Yucca - Sidewalk Easement Issue

BOE Condition 2 says: "That a 5-foot wide public sidewalk easement be provided along Argyle Avenue to complete a 12-foot sidewalk including a 10-foot by 10-foot or 15-foot radius property easement line return at the intersection with Yucca Street in accordance with Local Street Standards of LA Mobility Plan."

BOE Condition 3 says: "That a 6-foot wide public sidewalk easement be provided along Yucca Street to complete a 12-foot wide sidewalk area in accordance with Local Street Standards of LA Mobility Plan. Additional public sidewalk easement shall be provided at the location of the drop-off to complete a 12-foot sidewalk area."

1. ARGYLE AVENUE

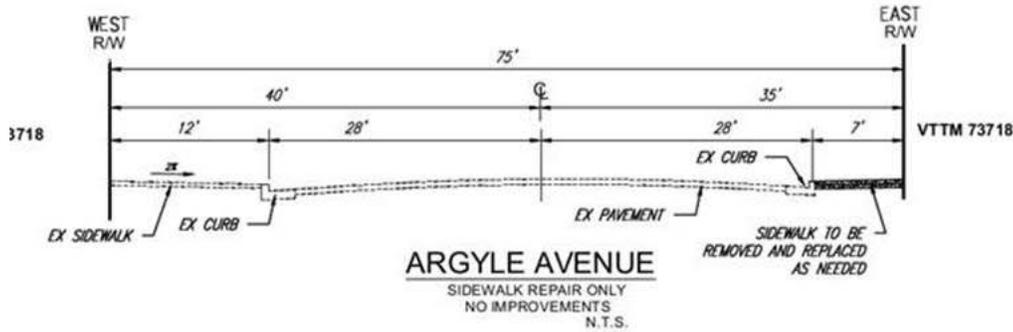
Under Mobility Plan 35, Argyle Avenue is listed as a Local Street Standard, which mandates a ROW width of 60' and a road width of 36' (which means 12' sidewalks).

However, Argyle Ave has a 75' ROW and a 56' road width (ROW confirmed width via the City's cadastral map).

And though we do not provide the 12' Mobility Plan sidewalk with the Project, inclusive of approximately 2 feet of sidewalk on the site, we more than meet the half ROW requirement and the road is in excess of the road width requirement.

Because we are over the half-ROW, we believe there should be no request to dedicate. But we do not understand having to provide a sidewalk easement into the Property where we can extend the sidewalk into the street. Why should we have to give up

2. YUCCA STREET

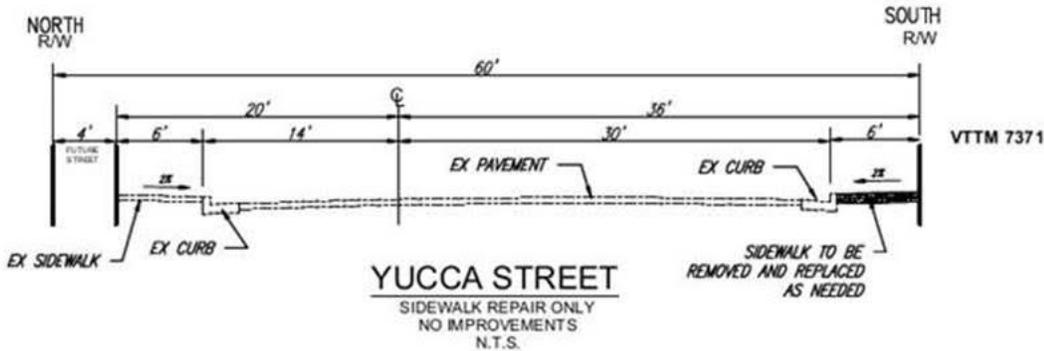
Under Mobility Plan 35, Yucca Street is also listed as a Local Street Standard, which as stated mandates a ROW width of 60' and a road width of 36'.

In accordance with the City's cadastral map, the total ROW currently is 56' – and that is not including the bulb out at the corner of Yucca St. and Vista Del Mar, which extends a little further into the street. The opposite side of the street is subject to a 4' dedication, which would take the street up to 60'.

However, the half-ROW on our side is 36', because the center line skews away from the Project Site (this appears to be the result of two prior, pretty substantial dedications provided from the Project's south side of the street). The Project Site would thus meet its total half-row requirement with approximately 6' to spare, meaning there would be no basis for BOE to request a dedication, as opposed to a potential requirement to widen the sidewalk into the street. With this extra ROW, why should we have to give an easement that encroaches into our building where there could not be a dedication?
